COUNTY OF GLENN

REQUEST FOR INFORMATION (RFI)

Solicitation Description: Jane Hahn Building ADA Improvements

RFI Number: 001

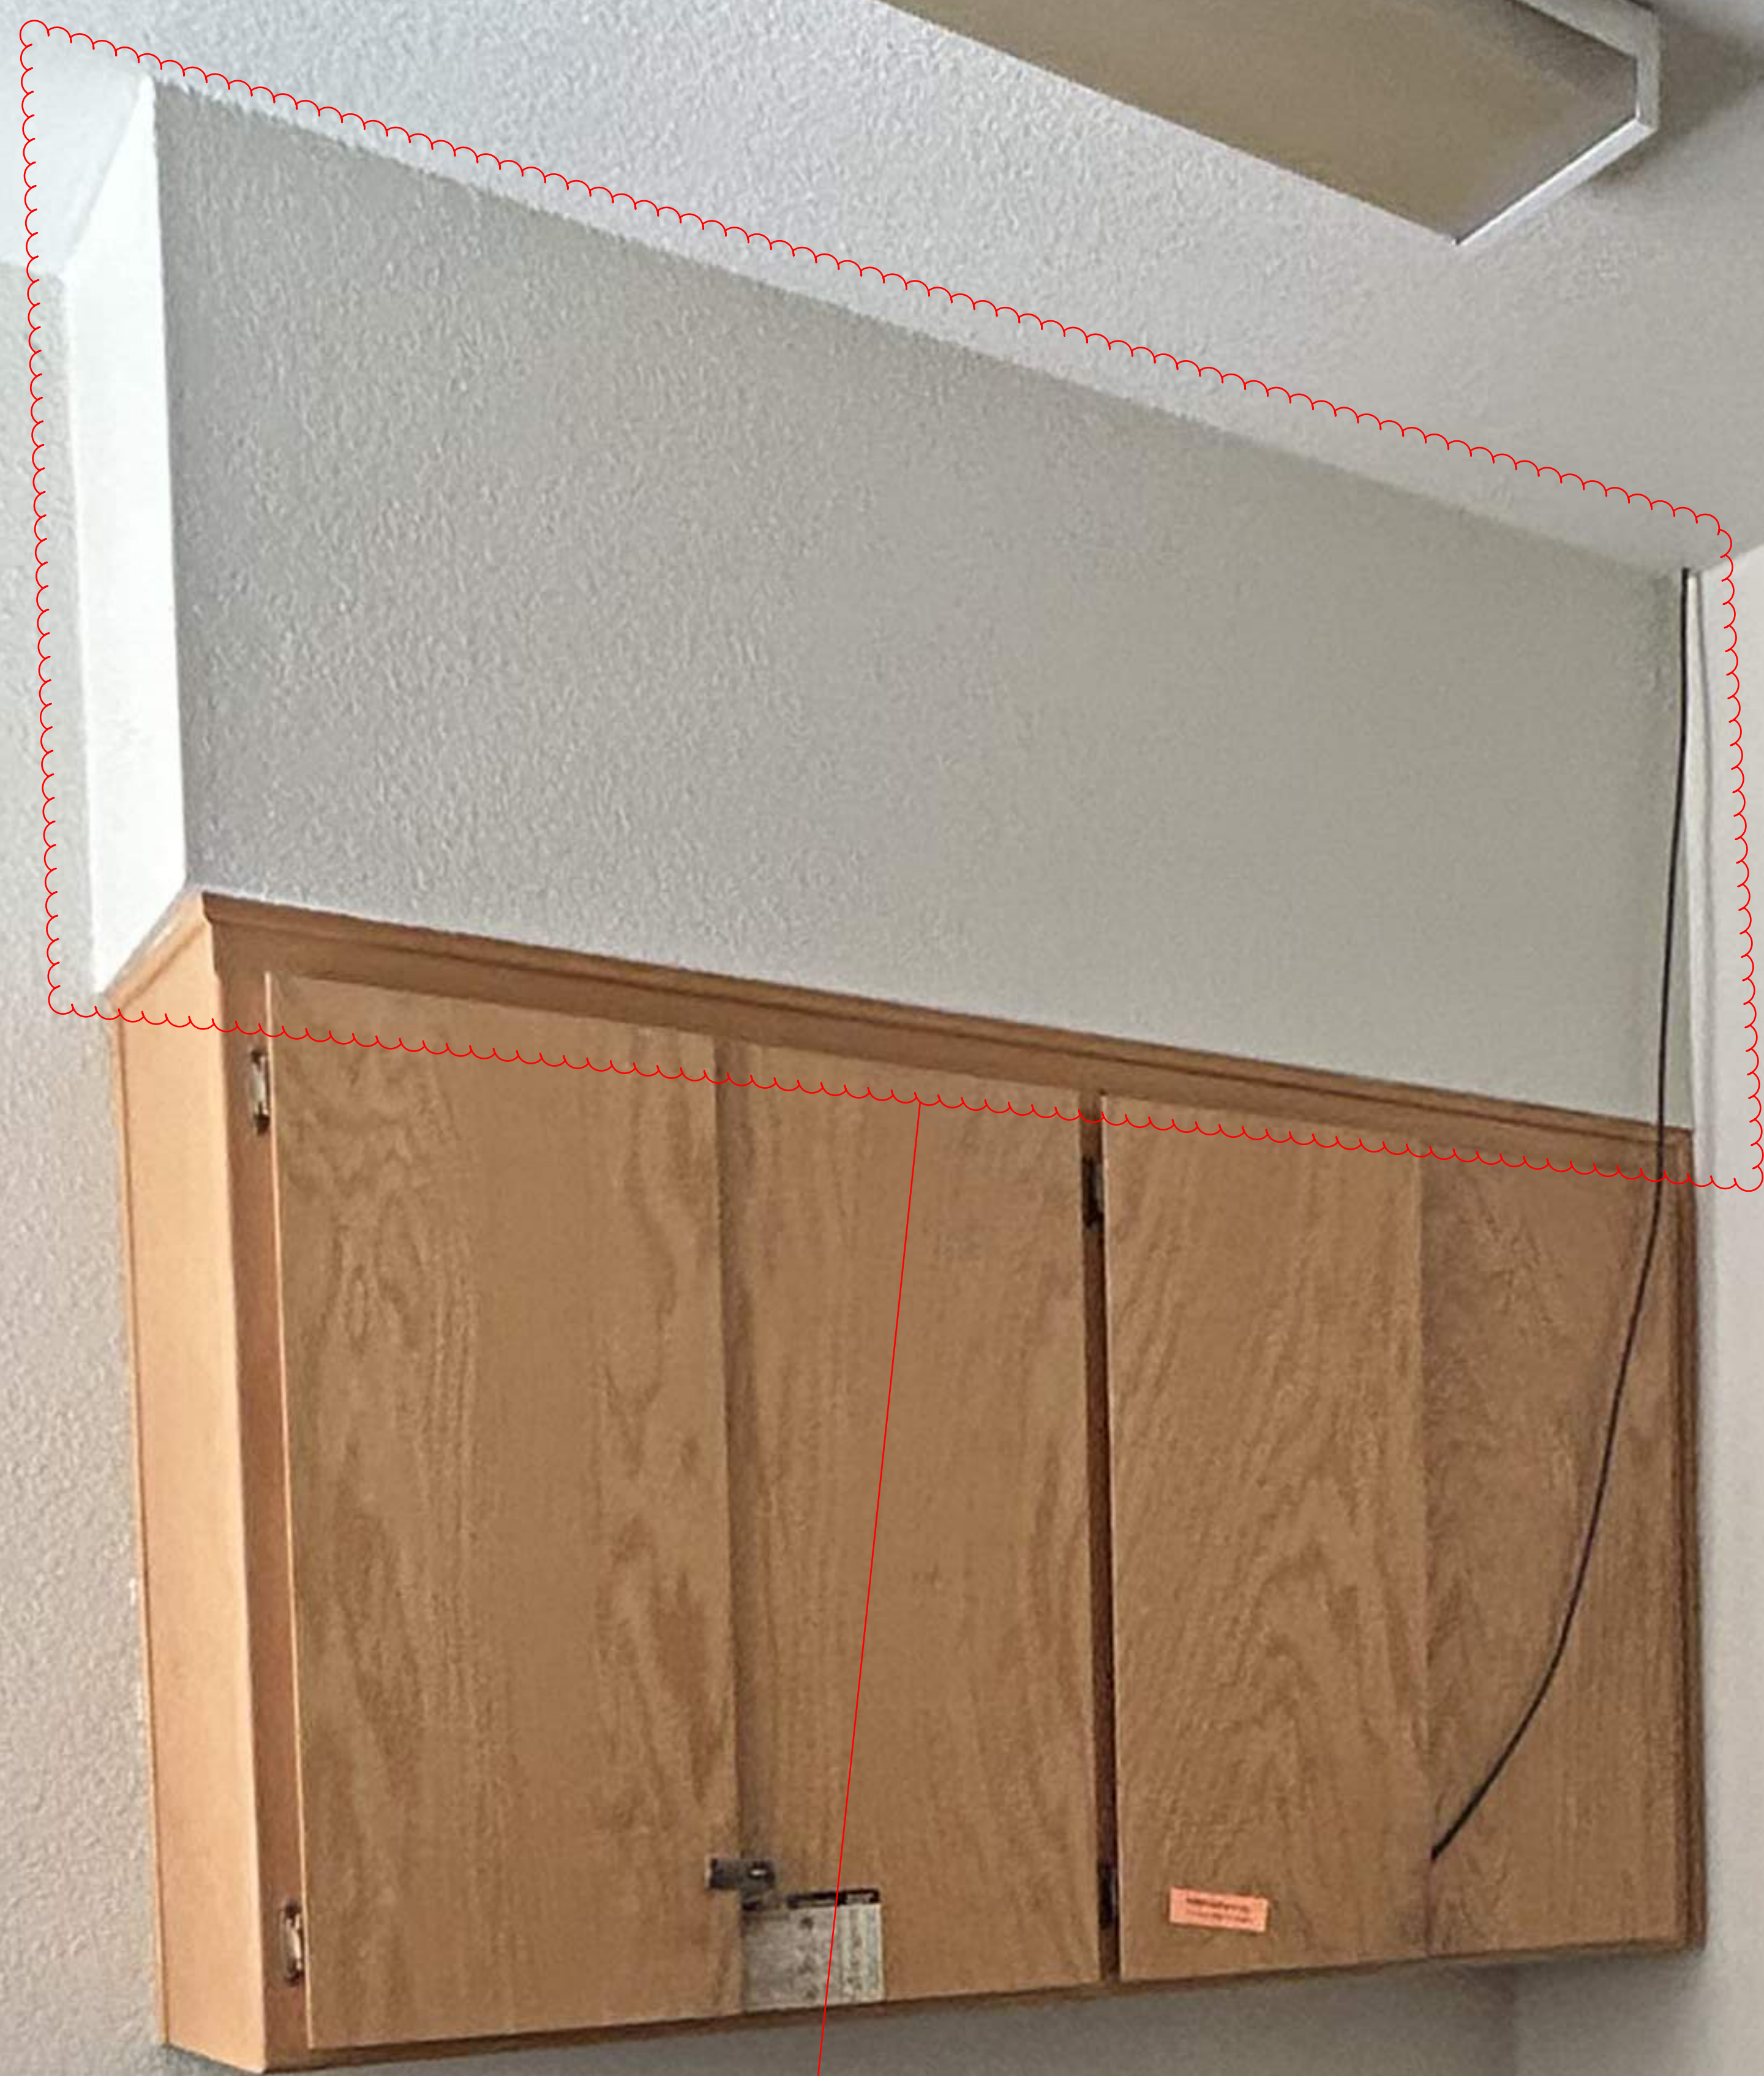
7. **Question:** Casework to be removed on west wall of expanded lobby, is there anything inside the chase above casework and is this to be demolished or remain in place?
7. **Response:** There is nothing in the chase above the case work, this it to be demolished and finished in accordance with plans and specifications. See pictures of chase as Attachment 2 to this document.

Wall casework to be removed per plan. What is inside this chase? Will this chase be demo'd or remain?
